Summary Presentation for TDD MPCP Enhancements (baseline proposal)

Andrea Garavaglia and Patrick Stupar
(Qualcomm)

Summary of proposed changes (new slide)

CLT Control Multiplexer - Service Interfaces

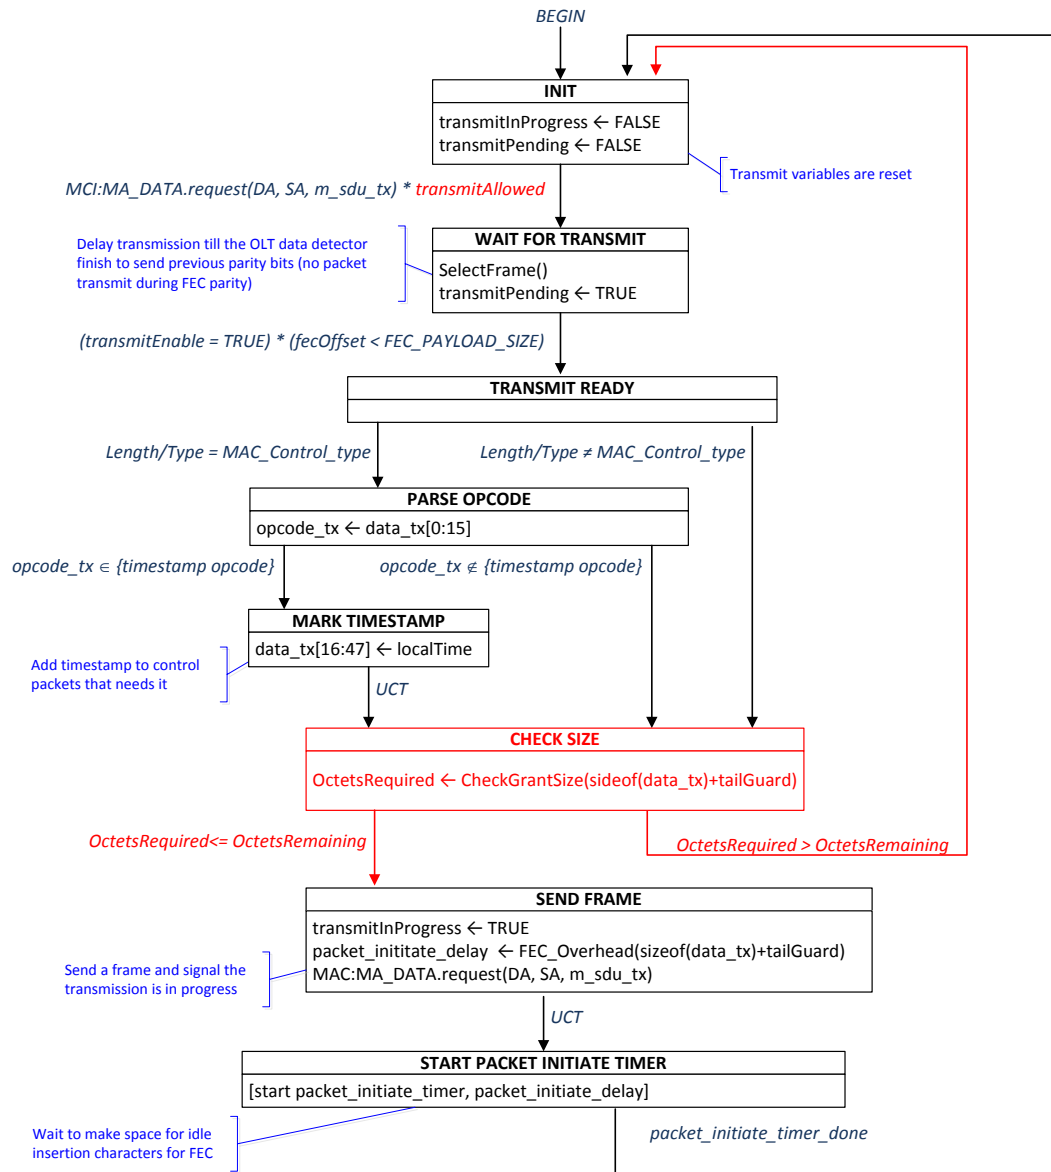
Applicability of *transmitAllowed* (in clause Z.2.2.3 – Variables)

*This variable is used to control PDU transmission at the CNU and at the CLT. It is set to true when the transmit path is enabled, and is set to false when the transmit path is being shut down. *transmitAllowed* changes its value according to the state of the Gate Processing functional block.*

State Machine of CLT Control Multiplexer

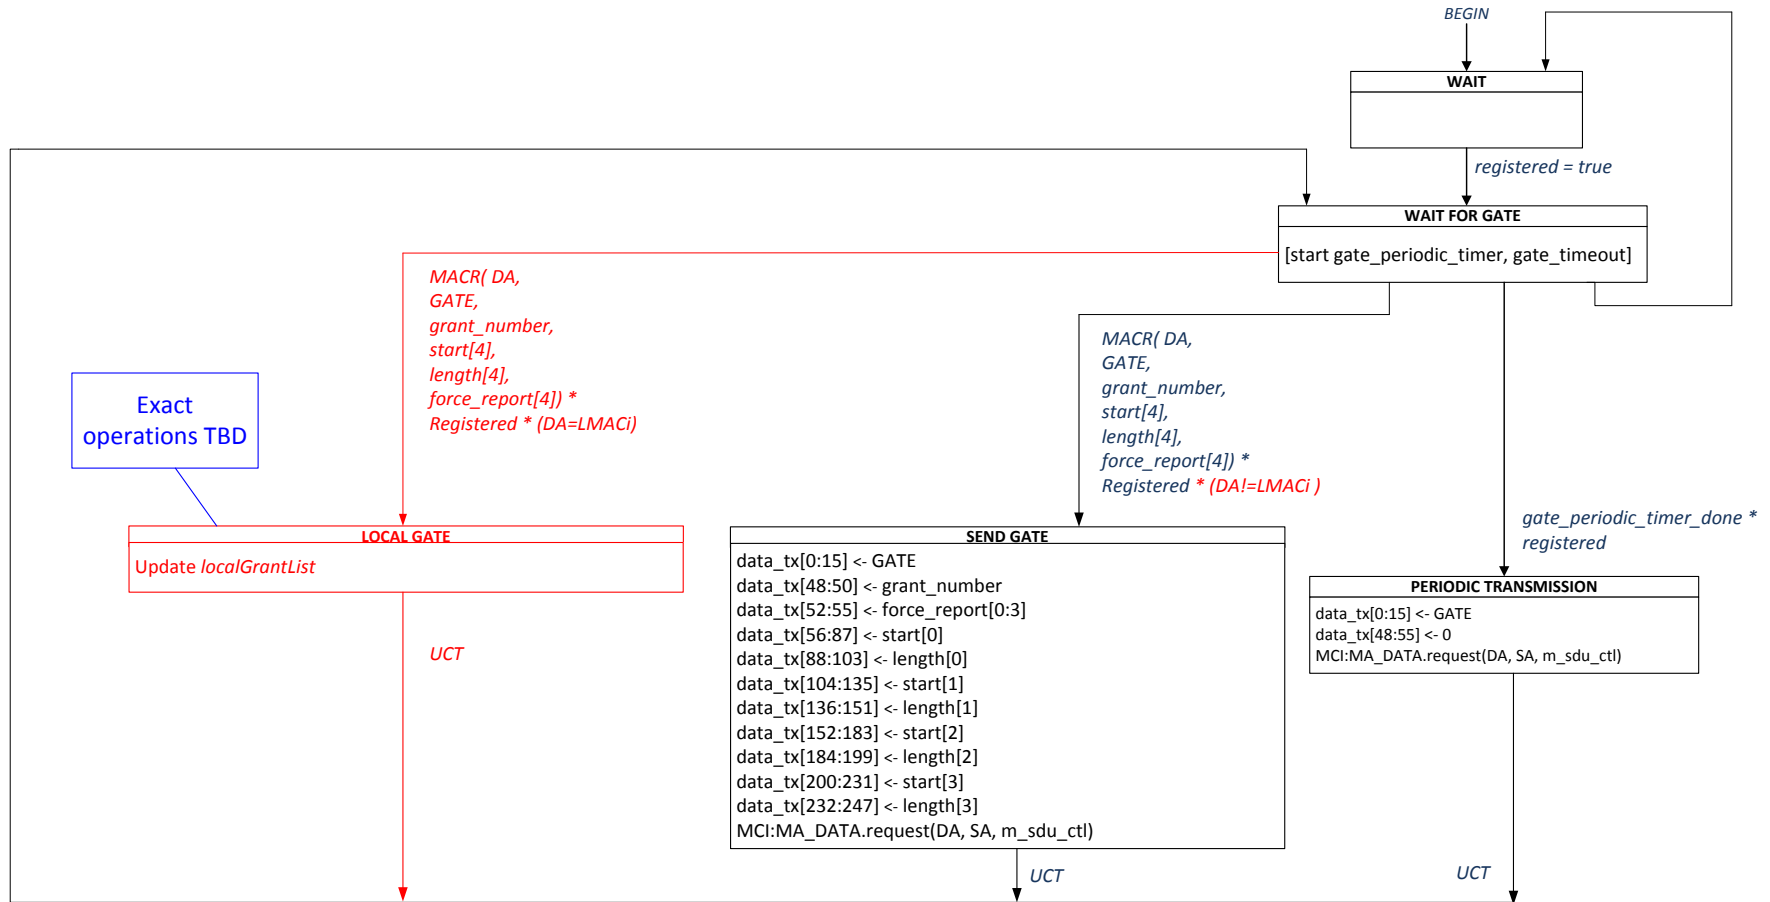
Source: Figure 77-13 (OLT Control Multiplexer state diagram) in Clause 77.2.2.7

Extended with parts of Figure 77-14 (ONU Control Multiplexer state diagram)

Gate processing in CLT for local (TDD) grant

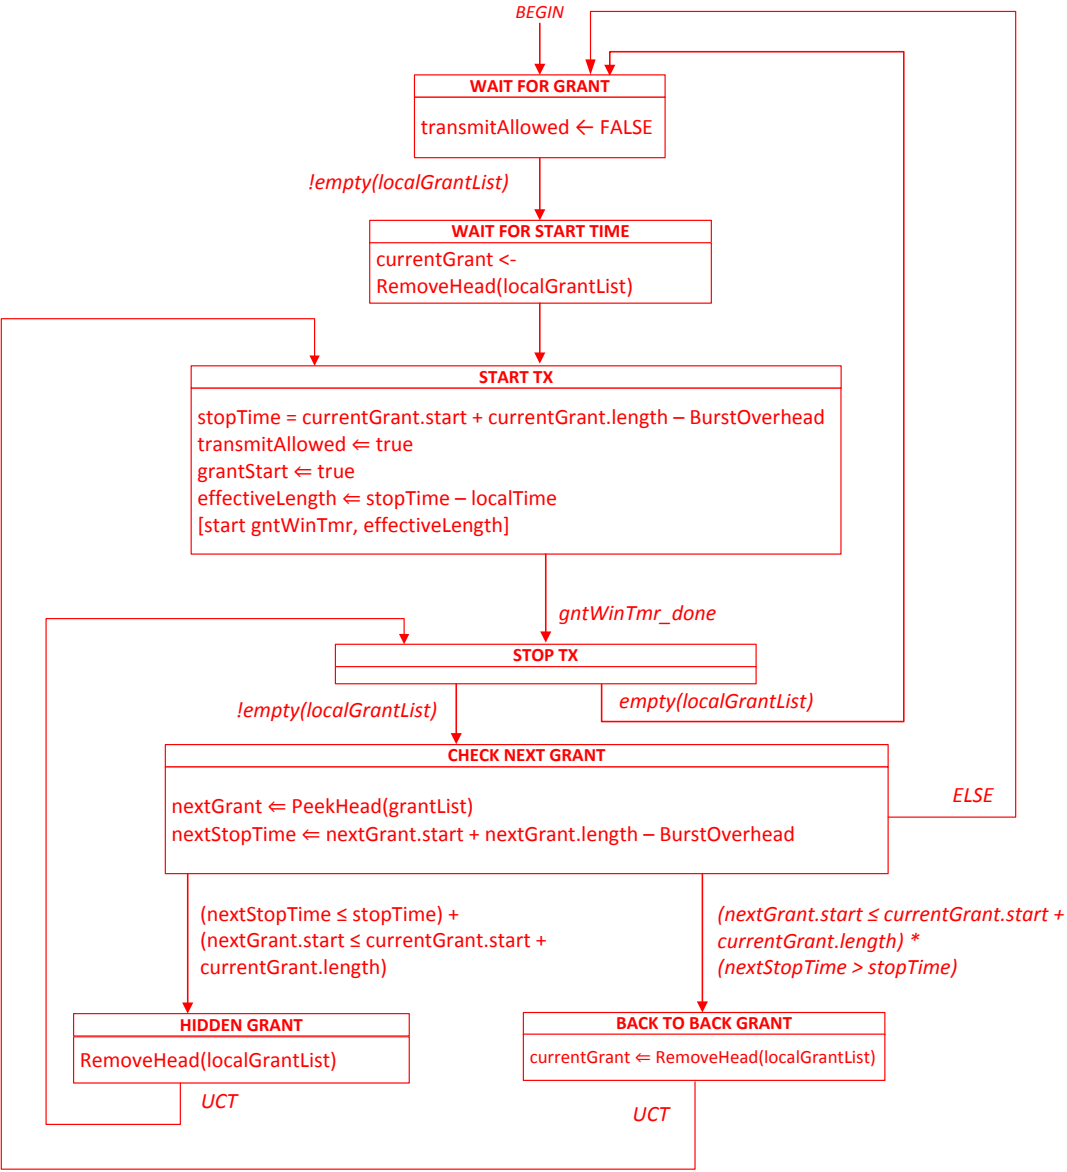
State machine derived by extending state machine defined in Figure 77-28 (Gate Processing state diagram at OLT) from clause 77.3.5.6
